ORDINANCE NO. 5089

AN ORDINANCE APPROVING A LANDSCAPE PLAN AND STREET TREE PLAN FOR THE BAKER CREEK NORTH SUBDIVISION

DECISION, CONDITIONS, FINDINGS OF FACT AND CONCLUSIONARY FINDINGS FOR THE APPROVAL OF A LANDSCAPE PLAN AND STREET TREE PLAN FOR THE BAKER CREEK NORTH SUBDIVISION

DOCKET: L 12-19 (Tree Removal, Landscape Plan and Street Tree Plan)

Figure 4. Proposed Street Tree Plan

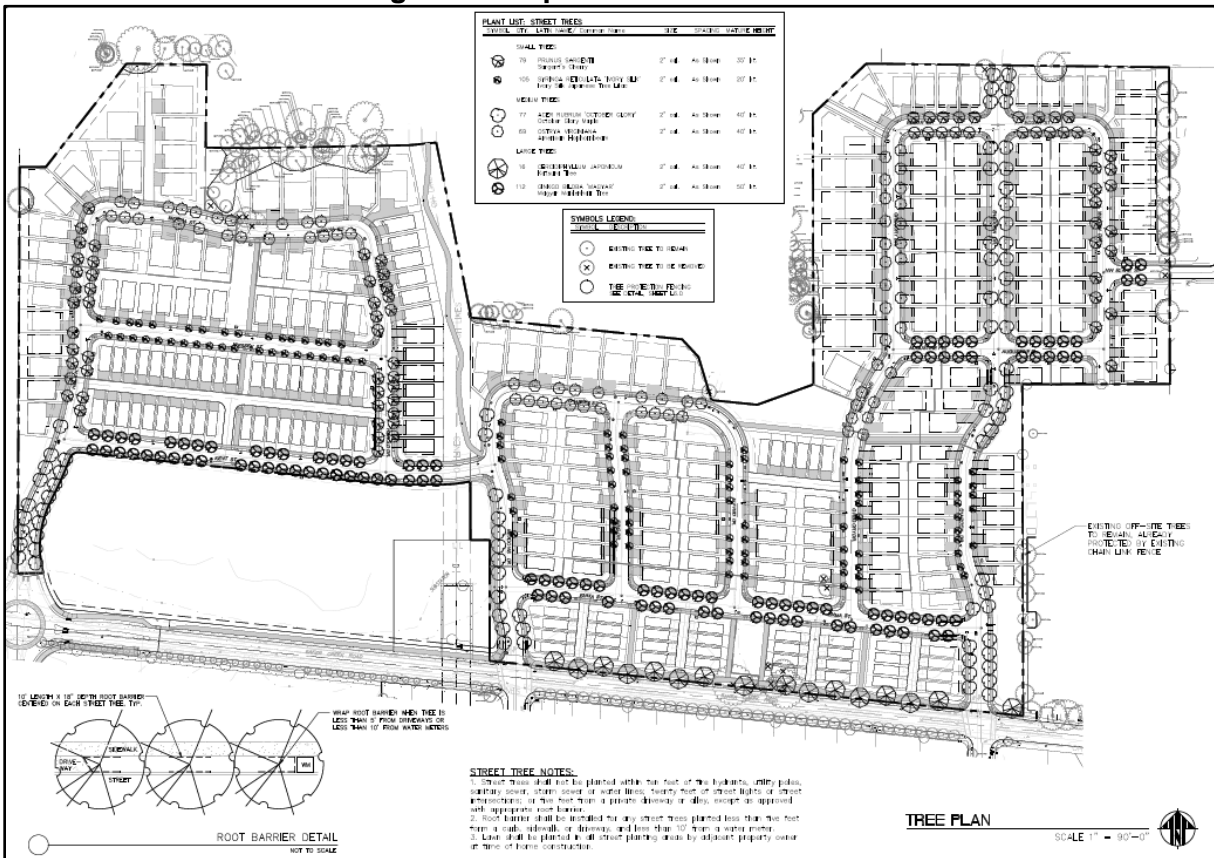
- Recognizing that street tree plans are reviewed and approved at a later date by the Planning Department and the Landscape Review Committee, we did note that several of the proposed tree locations will need to be adjusted due to probable conflicts with utilities and due to street sight distance concerns.

FINDING: SATISFIED WITH CONDITIONS OF APPROVAL #15 and 17. The Street Tree Plan has been requested for concurrent review and approval with the Planned Development and Subdivision applications. Approval of the Planned Development and Subdivision would allow variances to lot sizes and widths. The Street Tree Plan illustrates the proposed lot layout, along with proposed building envelopes, driveways, and utility locations. The applicant is requesting as part of the planned development approval street tree spacing that varies from the standards of the code as shown on the drawing L1.0 Street Tree Plan. In higher density developments lot frontage decreases and frequency of driveways and utilities increase, creating conflicts that require greater spacing between street trees than outlined in the code. The applicant notes that the planned development compensates for the increase in spacing in the following ways:

5. That only the 17 existing trees identified for removal on Drawing L1.0 Street Tree Plan shall be approved for removal.
6. That landscaping be provided for Sewage Pump Station Tract 'G'. Landscaping shall be provided at an amount equal to or greater than 25 percent of the gross area of the tract, and shall provide screening of the pump station structure from surrounding properties.

- iv. *Ostrya virginiana* (American Hophornbeam)
 - v. *Prunus sargentii* (Sargent Cherry)
15. That street trees in addition to those shown on the Street Tree Plan dated 11/18/2019 shall be provided in the following locations, unless a utility is present that creates a setback requirement:

Pump Station 'Tract G':

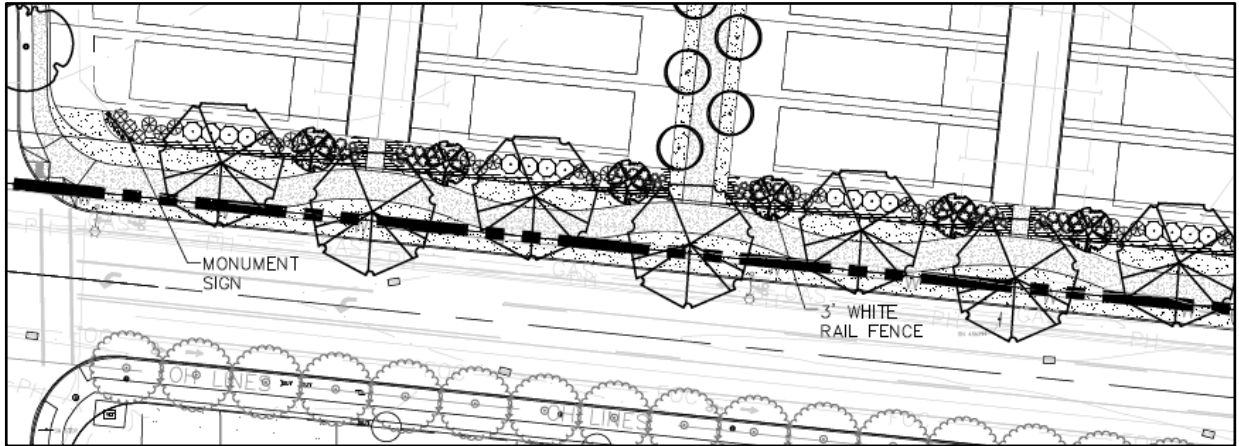
Landscaping has been proposed in excess of the 25 percent minimum for each common tract in the planned development, except for Tract G, the sewage pump station tract. Therefore, a condition is included requiring a minimum 25 percent of the gross area of Tract G be provided with landscaping.

Landscaping was not proposed for Tract G at the intersection of Charles Street and Alfred Drive, where a sewer pump station is located. Tract G is adjacent to residential lots 60, 109, and 110, and is across the street from lots 49, 111, and Open Space Tract F. There is no screening or buffering of the pump station from the adjacent residential uses. A condition of approval requiring landscaping to screen and buffer the sewage pump station has been included.

CONDITION FOR FINDING: That landscaping be provided for Sewage Pump Station Tract 'G'. Landscaping shall be provided at an amount equal to or greater than 25 percent of the gross area of the tract, and shall provide screening of the pump station from surrounding properties.

Open Space 'Tract I':

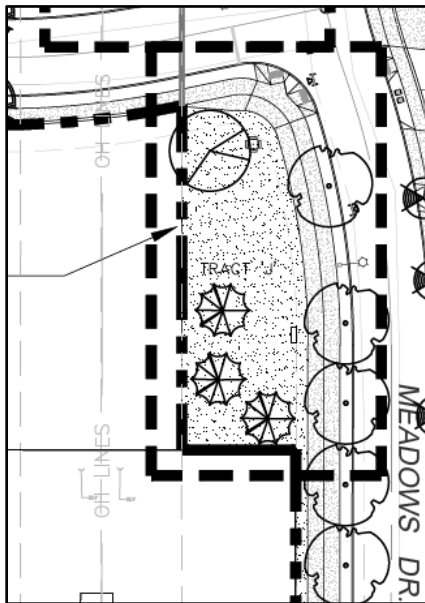
Based on comments from McMinnville Water & Light, trees surrounding the electric substation should be limited in height to 25 feet. A condition is included limiting the height of any trees located in Open Space Tract I to a maximum mature canopy height of 25 feet.

Open Space 'Tract J':

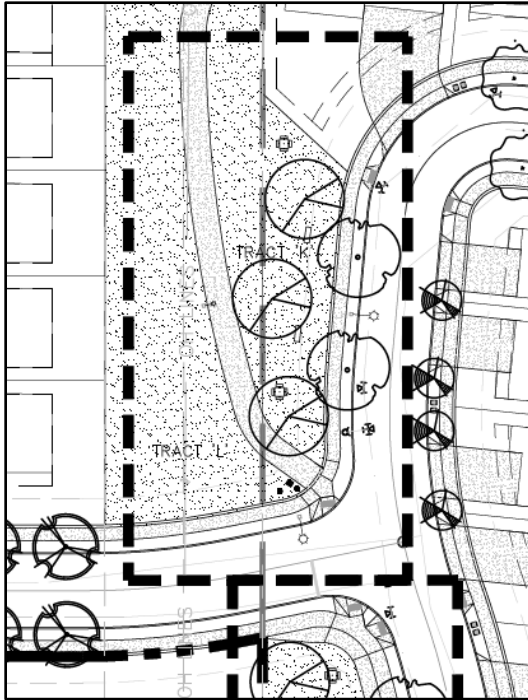
Douglas Fir trees can grow to approximately 100 feet tall and 30 feet wide, and Sunburst Honey Locust grow to approximately 40 feet tall and wide. Based on comments from McMinnville Water & Light, trees surrounding the electric substation should be limited in height to 25 feet. Additionally, trees adjacent to the transmission easement should be limited in height 40 feet and located such that no canopy encroaches into the transmission easement. A condition is included limiting the height of any trees in Open Space Tract J adjacent to the electric substation to a maximum mature canopy height of 25 feet, and no tree in Tract J shall

exceed a maximum mature canopy height of 40 feet or be located such that no canopy encroaches into the transmission easement.

Open Space 'Tract K':

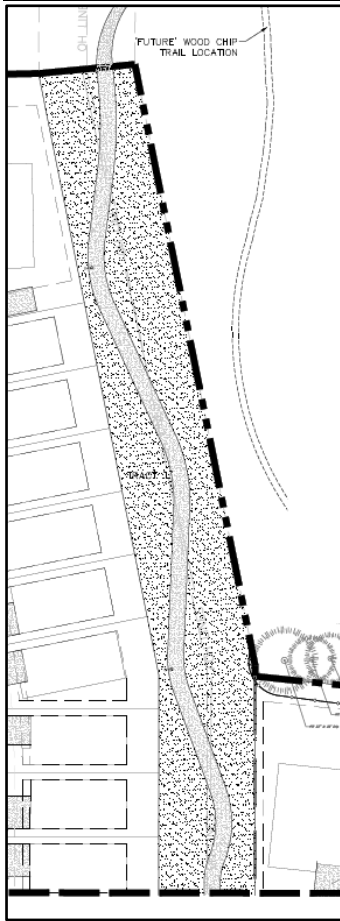
Sunburst Honey Locusts grow approximately 40 feet tall and wide. Based on comments from McMinnville Water & Light, trees in Tract K should be located such that no canopy encroaches into the transmission easement. A condition is included limiting the height of any trees in Open Space Tract K to a maximum mature canopy height of 40 feet and to locations such that no canopy encroaches into the transmission easement.

Open Space & Access Easement 'Tract L':

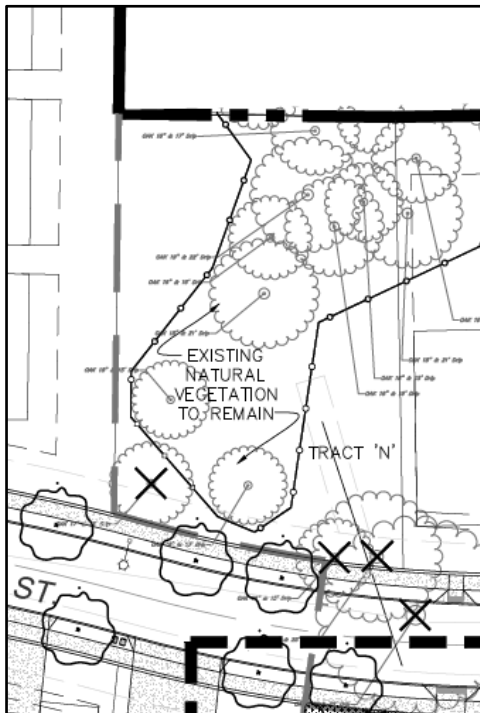
Additionally, no street trees should be located within the public right-of-way in the transmission line easement, where they would be in incompatible with electrical transmission lines overhead.
